**Project #16-026**  
**Aaron's Elite Automotive**  
**Located at 1098 West 130 South**

**REPORT SUMMARY...**

*Project Name:* Aaron's Elite Automotive  
*Proponent / Owner:* Hal Fronk / VRUGG Holdings  
*Project Address:* 1098 West 130 South  
*Request:* Design Review Permit  
*Current Zoning:* Commercial Services (CS)  
*Type of Action:* Quasi-Judicial  
*Hearing Date:* June 23, 2016  
*Submitted By:* Russ Holley, Senior Planner

## SITE PLAN

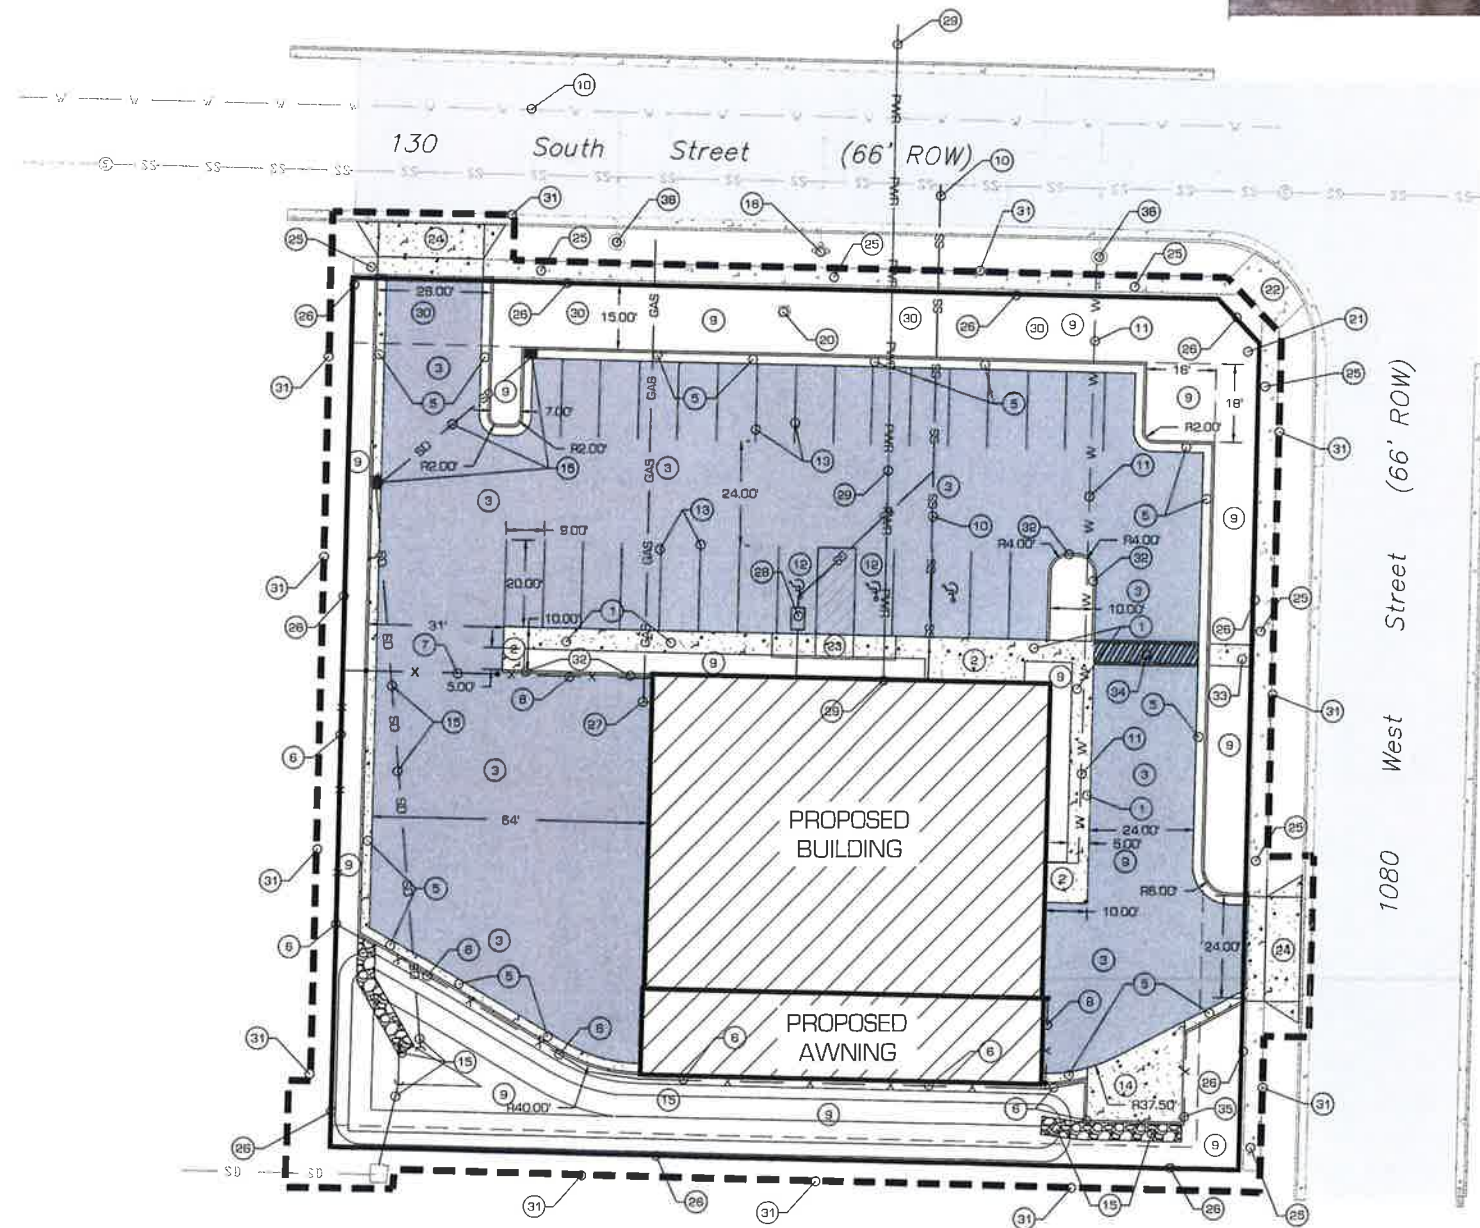
When parking lots are located near streets, the LDC 17.39.070, requires certain amounts of landscape screening based on proximity to the road. The different types of screening levels are outlined in the code and generally require landscaping and/or earth berms. The applicant has proposed parking lots with a 20' & 30' offset from the street, which would require a type "A" for the 30' setback and a type "B" for the 20' setback. Type "A" screening requires minimal ground cover or landscaping and type "B" screening requires a combination of shrubs and trees spaced closer together to buffer parked cars from the street. As conditioned with the "Type B" landscaping along the north frontage, the proposed project meets the requirements of the LDC.

The LDC also requires a minimum of 30% transparency on street facing facades. The proposed area of transparent windows on the street-facing façades is 29% (north) and 31% (east, excluding the awning area). As conditioned, the project meets building elevation requirements in the LDC.

1. All standard conditions of approval will be recorded with the Design Review and are available in the Community Development Department.
2. The Planning Commission accepts the 29% of transparency on the north facade as substantial compliance to the LDC.
3. A performance landscaping plan, prepared in accordance with §17.39 of the LDC, shall be submitted for approval to the Community Development Department prior to the issuance of the building permit. The plan shall include the following:
  - a) Street trees along all adjacent streets provided every thirty (30) feet on center.
  - b) Open Space and Useable Outdoor areas shall total a minimum of 8,362 SF.
  - c) A total number 19 trees and 48 shrubs, perennials and grasses shall be provided.

- d) The landscaping areas between the parking lot and 130 South to the north shall consist of dense shrubs as per type "B" standards (LDC 17.39.070).
4. The dumpsters shall be visually screened or buffered from 1080 West street by using landscaping shrubs and bushes or fences/walls (fences and walls are limited to 4' tall in front yard)
